**RE: Guardian Storage- Juan Tabo
4909 Juan Tabo NE
Conceptual Grading and Drainage Plan Stamp Date: 12/20/19
Hydrology File: F21D081**

Based on the submittal received on 12/19/19, the Conceptual Grading and Drainage Plan is approved for Site Plan for Building Permit.

RE: Guardian Storage – Juan Tabo Conceptual G&D Resubmittal (Hydrology File F21D081)

RESPEC requests review of the revised Conceptual Grading & Drainage Plan for the proposed Guardian Storage Development on Juan Tabo and Osuna. The updated plan contains revisions based on review comments provided on November 18, 2019. The review comments have been addressed by the following:

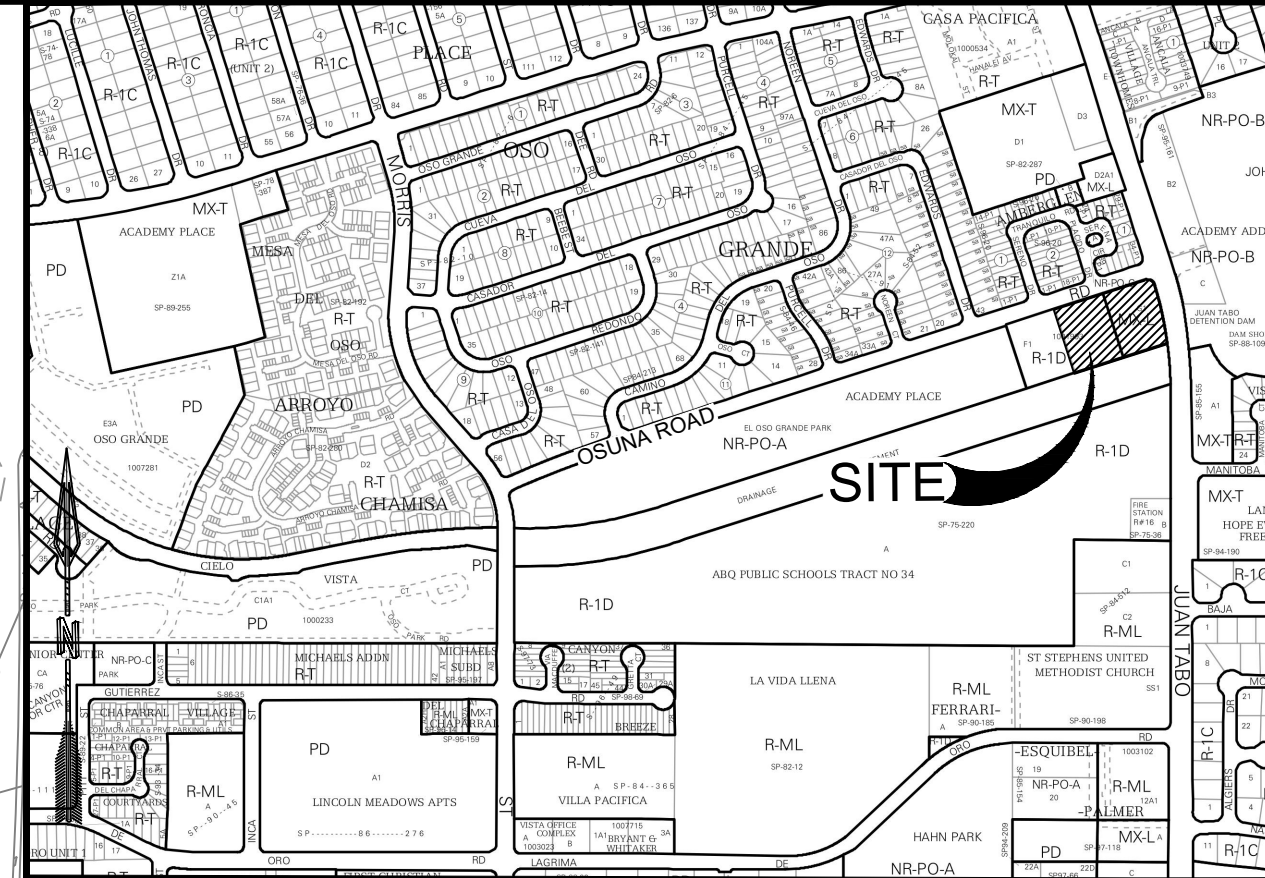
4. Provide slope easements (3:1) from the edge of ROW/PL down to the proposed grade along Juan Tabo, Osuna, and the arroyo.
Per discussion with Mr. Ernest Armijo, the slope easements can be forgone provided the design meets the sketch drawn up and sent to RESPEC on December 13, 2019 (attached to this letter). RESPEC will match the cross section provided in lieu of establishing slope easements.

Manning Formula: Osuna Road NE Driveway Section

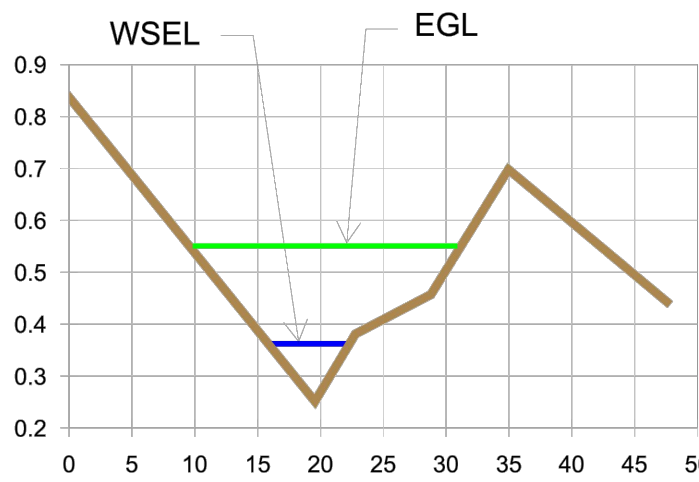
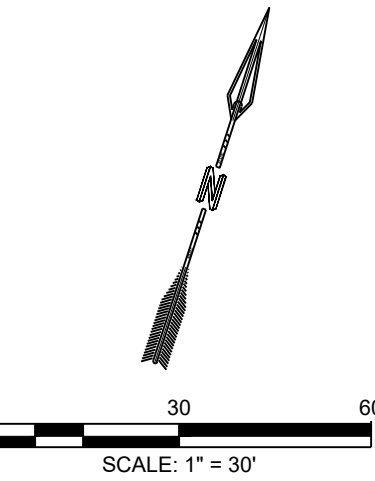
7. Provide a waterblock, 0.87' high at the drive entrance. Alternatively, provide flow depth (and EGL) calculations along Osuna to justify a lesser waterblock.
Calculations have been provided determining a flow depth justifying a lesser waterblock.

B NORTH PROPERTY LINE SECTION
SCALE: NTS

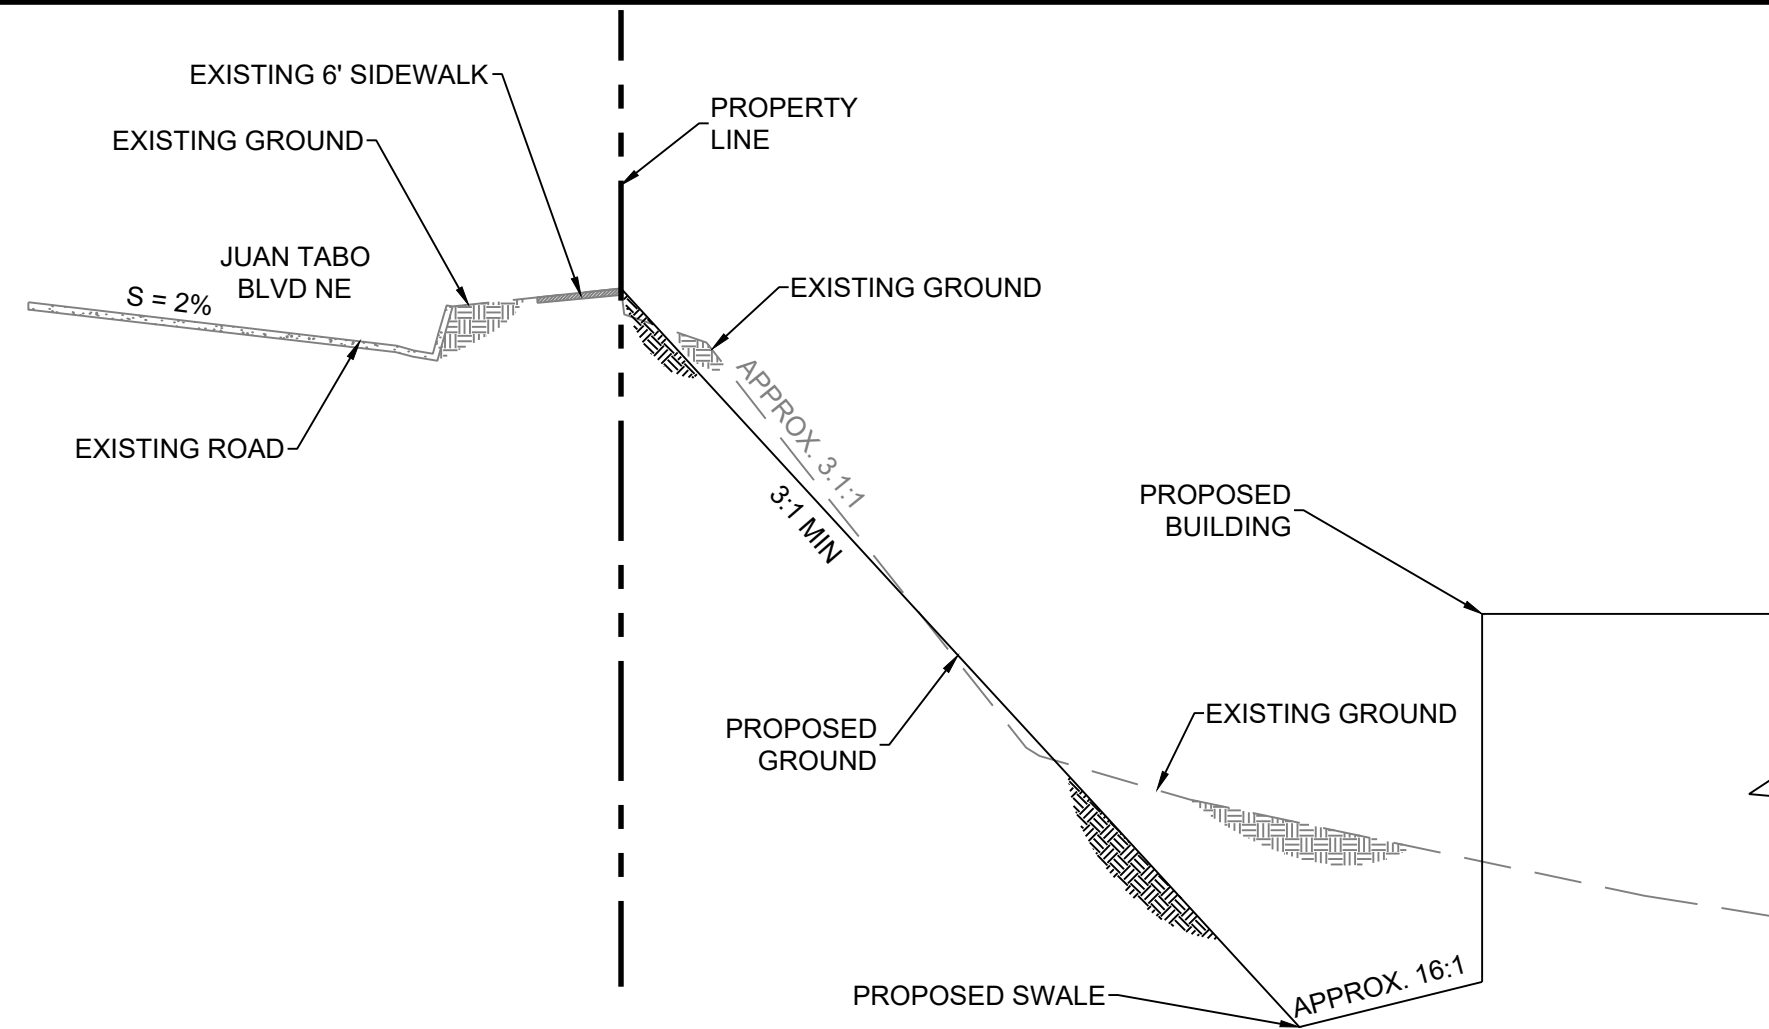
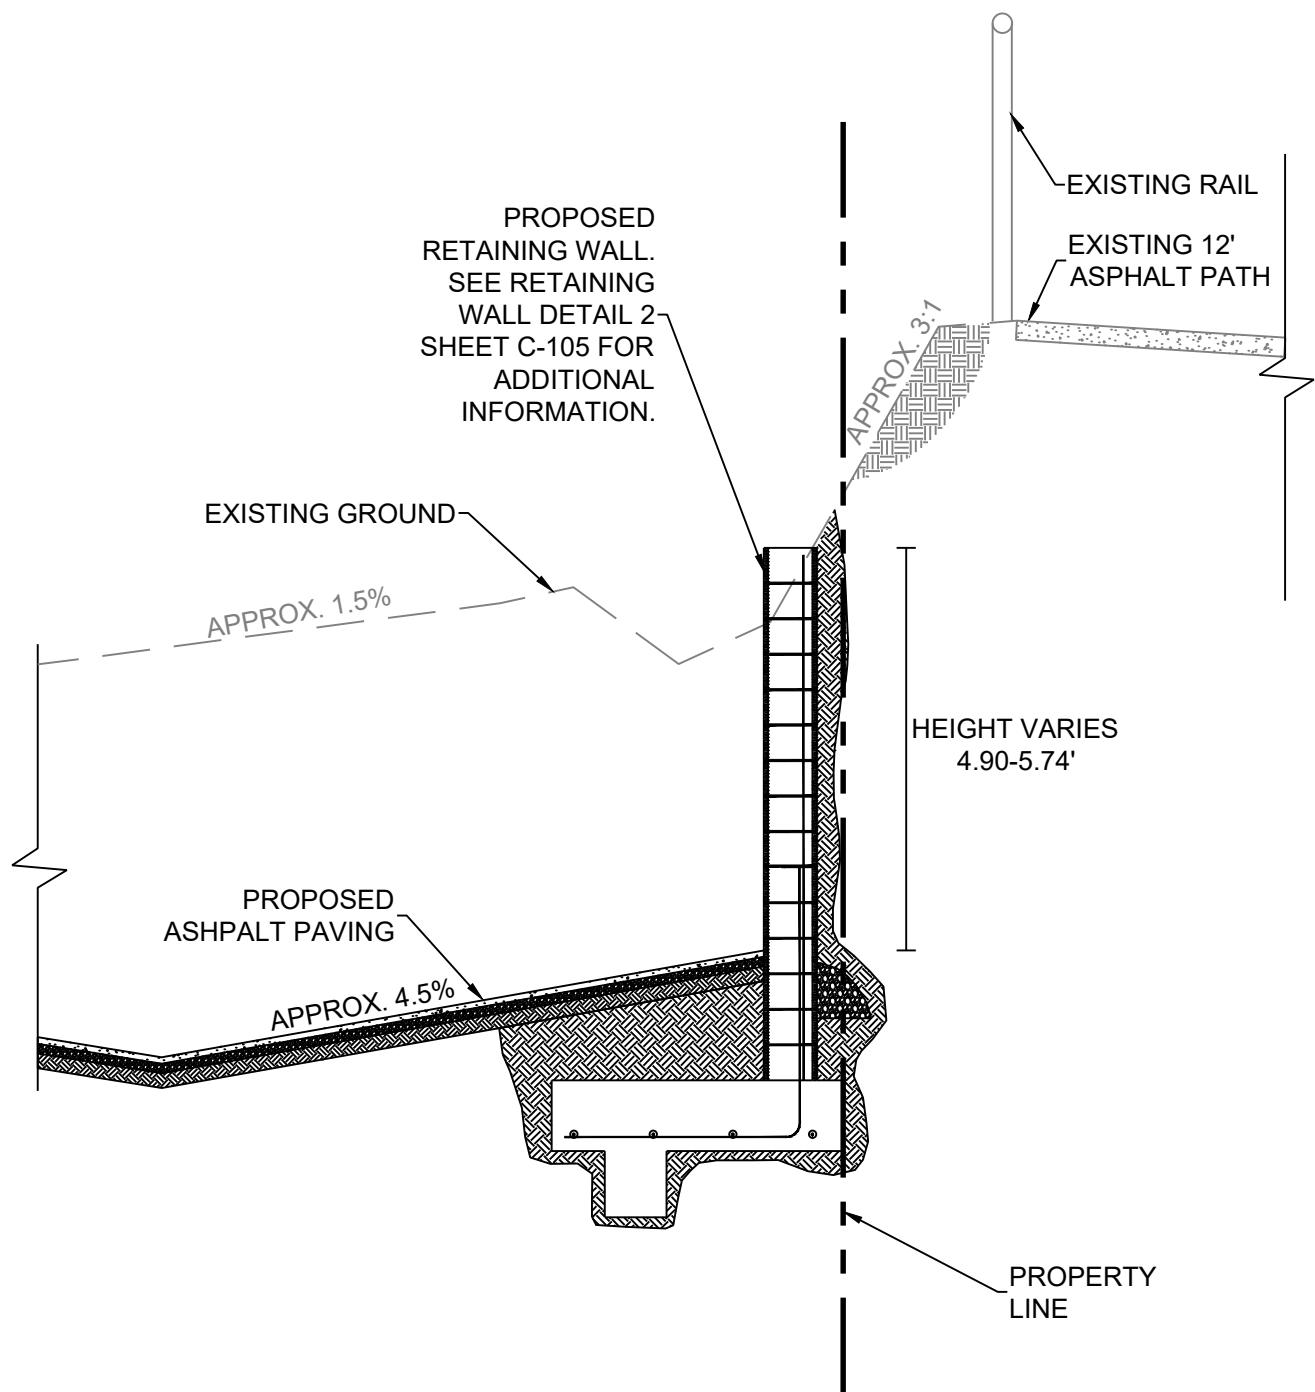
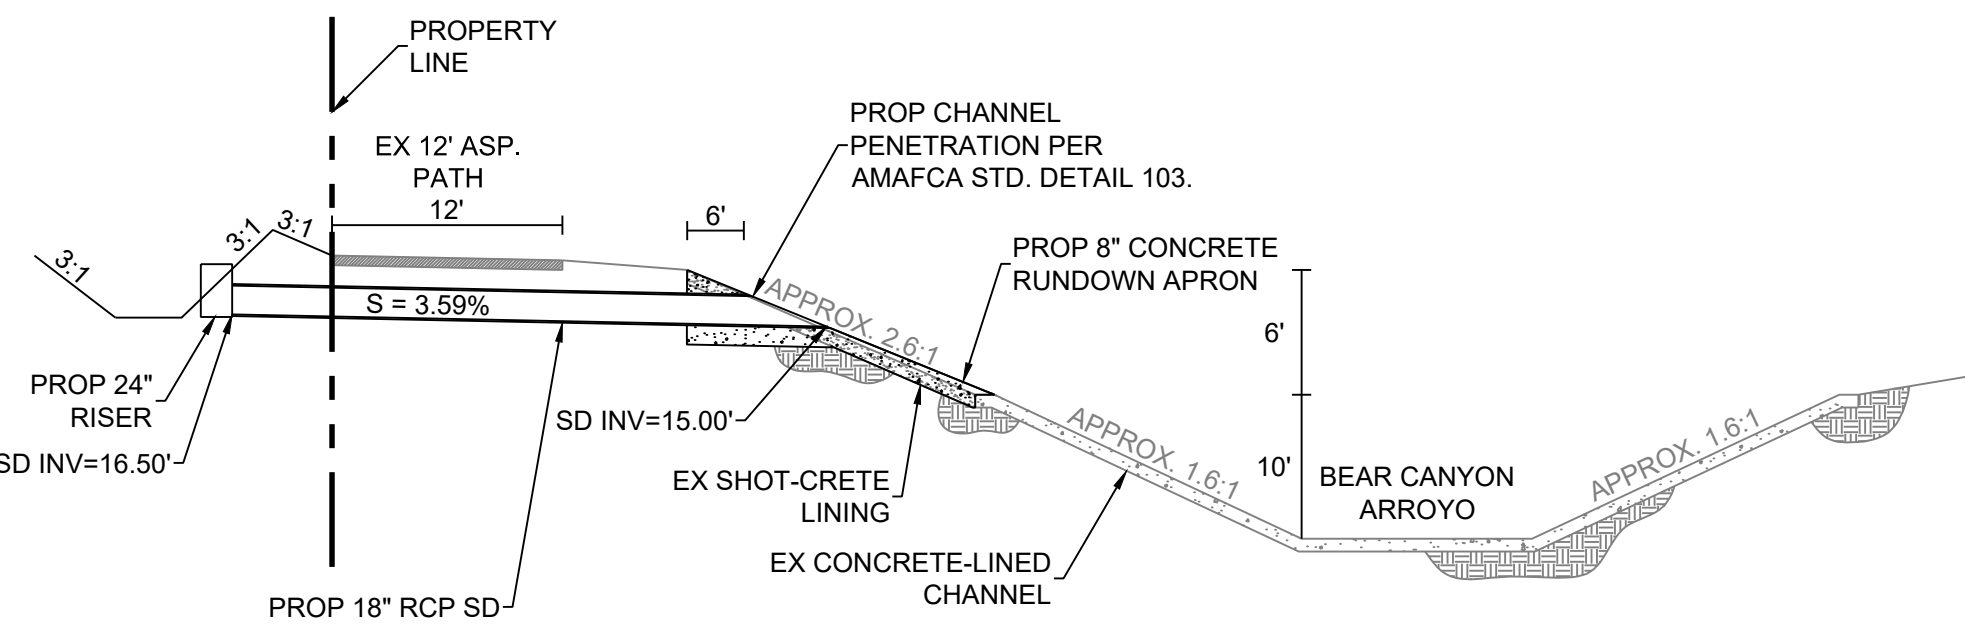
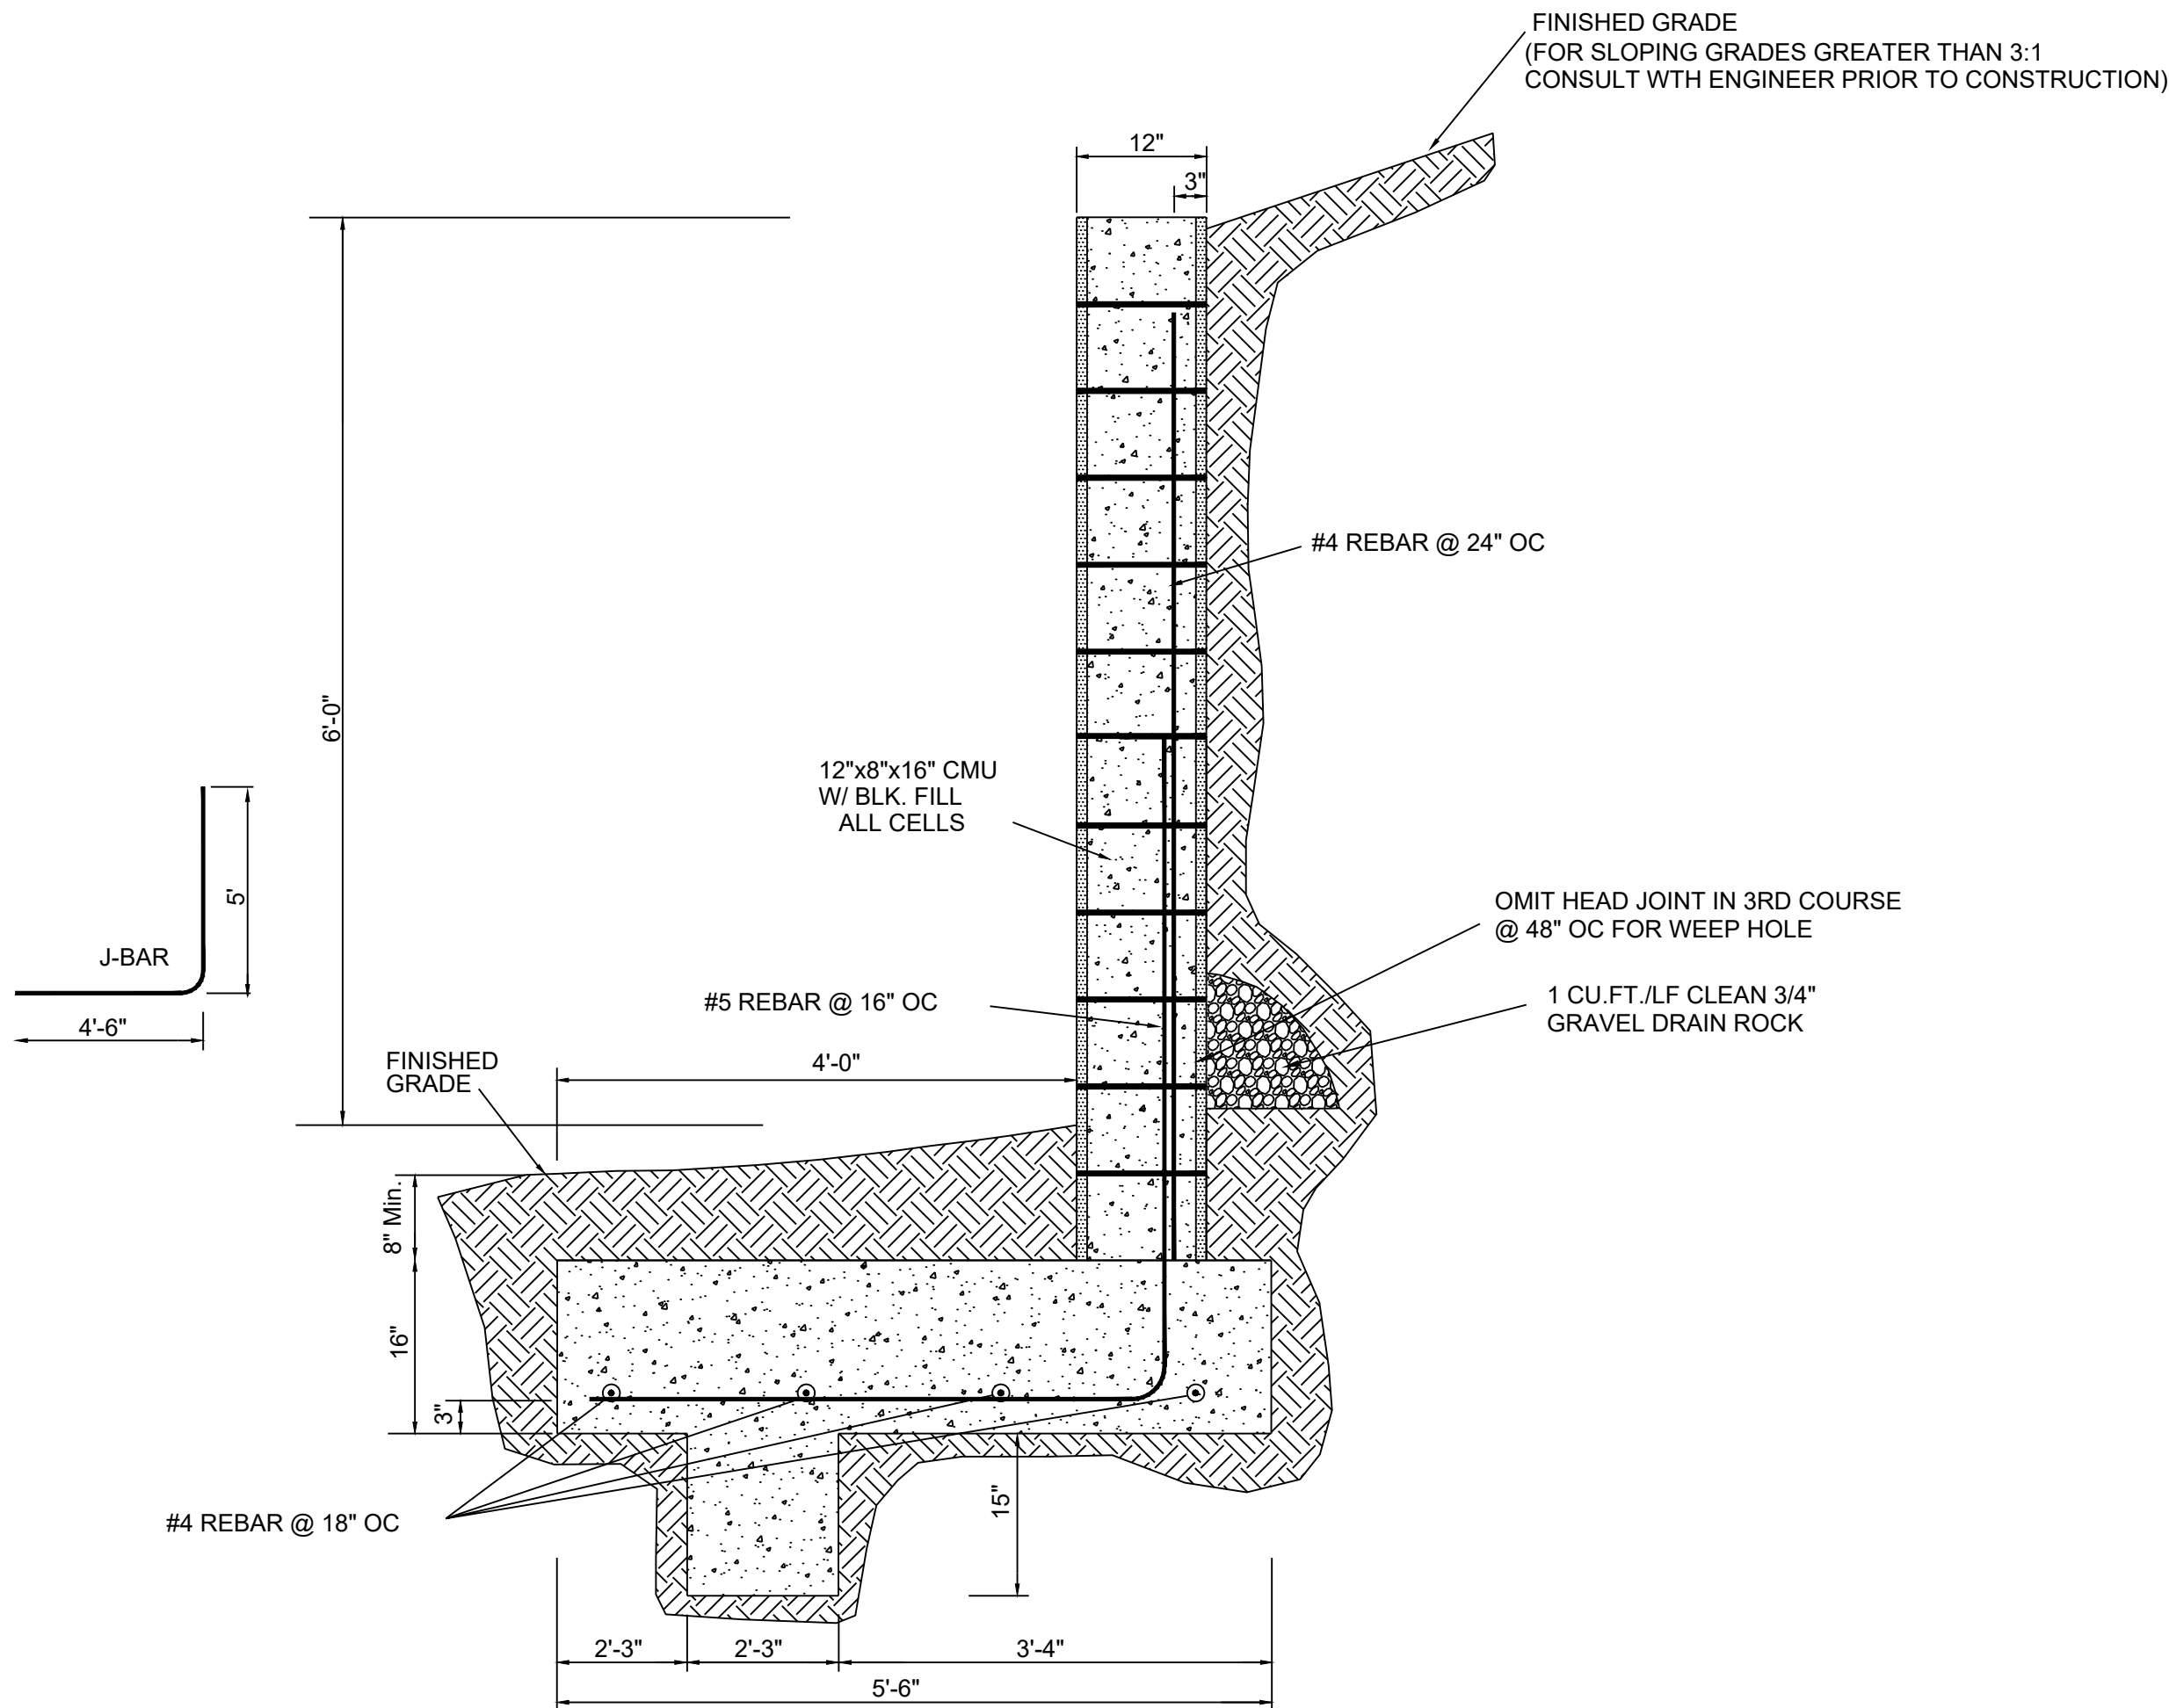
8. Provide sections through all external boundaries, especially the retaining wall adjacent to the arroyo, showing proposed retaining walls, garden walls, property/ROW lines, existing and proposed grades. In accordance with DPM Ch.22, section 5 part B, grading and wall construction near the property line may not endanger adjacent property or constrain its use.
Sections have been provided on all external boundaries, including retaining wall and pond outlet sections along south side of property.
9. Only one paper copy (plus the pdf) is required for Hydrology submittals.
Acknowledged.

F SPILLWAY DETAIL
SCALE: NTS

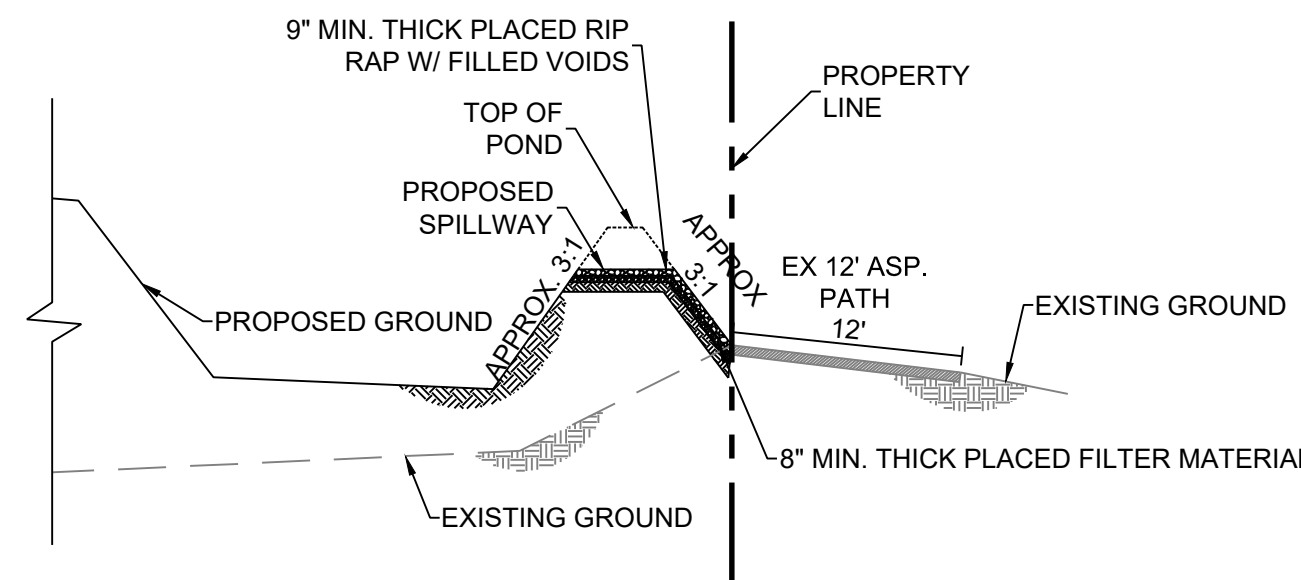
5. Provide slope protection anywhere slopes exceed 3:1.
Slope protection has been added on slopes exceeding 3:1.
6. Provide an emergency spillway (or 2x capacity on the outfall), sized for the 100-yr peak inflow on the proposed pond. The spillway must be directed to the arroyo easement, not the property to the west.
A weir emergency overflow has been added to the southern side of the pond, directed towards the arroyo and not to the west.
